TYPE NO All	TYPE Coffe Vending Machines	T.I. NO 04 - 2015				
SERIAL NUMBERS AFFECTED From and including S/N N/A	ISSUED BY Documentation/N&W Valbrembo					
SUBJECT INSTANT SOUP IMPELLER	ISSUED FOR (X): <table border="1"> <tr> <td>Action</td> <td></td> </tr> <tr> <td>Information</td> <td>X</td> </tr> </table>		Action		Information	X
Action						
Information	X

Below two pictures of the **Soup impeller**

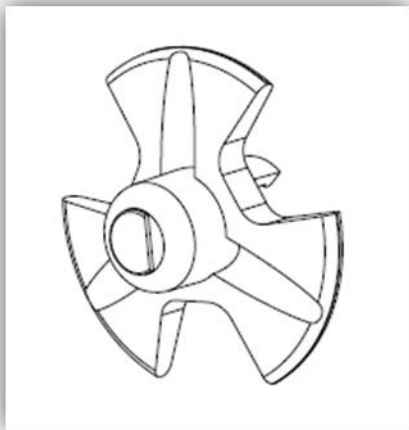
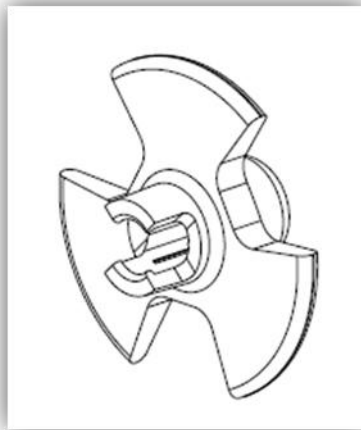
In order to optimize the incup quality for “**Soup**” instant product and to avoid clogging in the mixing system for some recipes setting, a new impeller has been introduced as spare.

Starting from the impeller in production, it is derived a new specific one.

Added three cut to reduce resistance.

The spare part code of the **Soup Impeller** is **258858**

The soup impeller can be installed in the mixer machines prior to the above mentioned serial number (back compatibility) and it is available as spare part.
